E8363C-02

S E R V I C E N O T E

E8363C PNA Microwave Network Analyzers

A new touchscreen display inverter shield is available to improve PNA noise floor performance.

Figure 3

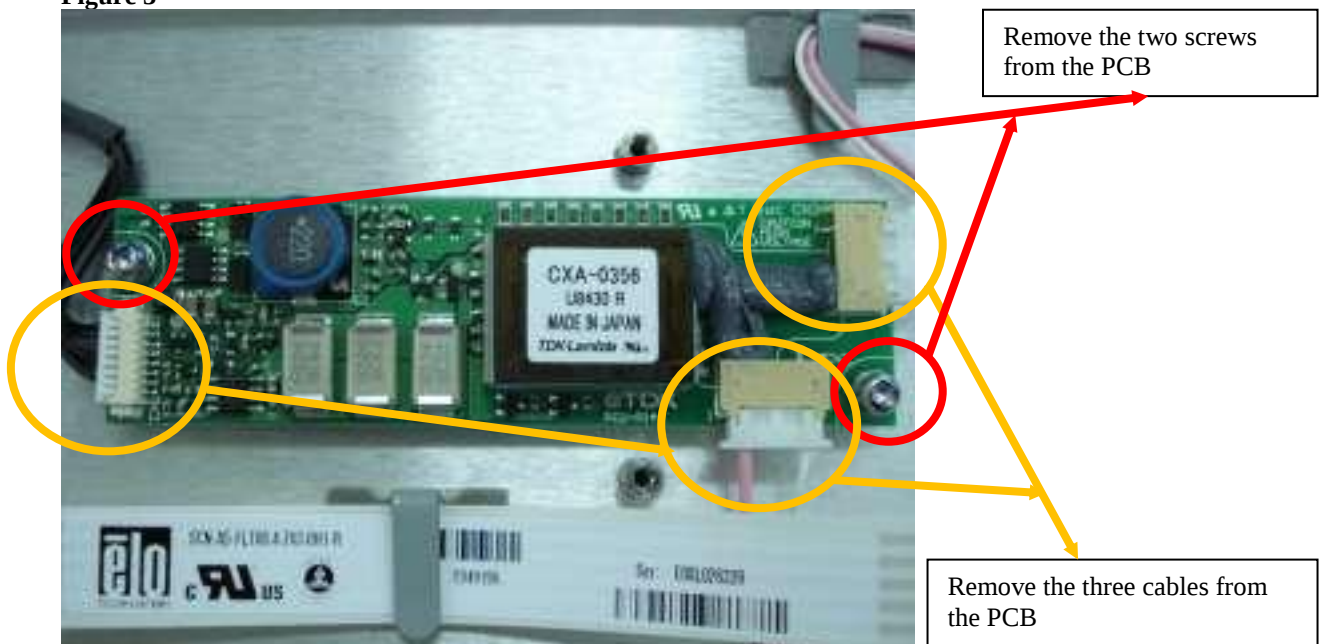
10. Remove the two screws from the PCB shown in Figure 3, using a T-10 wrench.
Disconnect the three cables connected to the PCB.
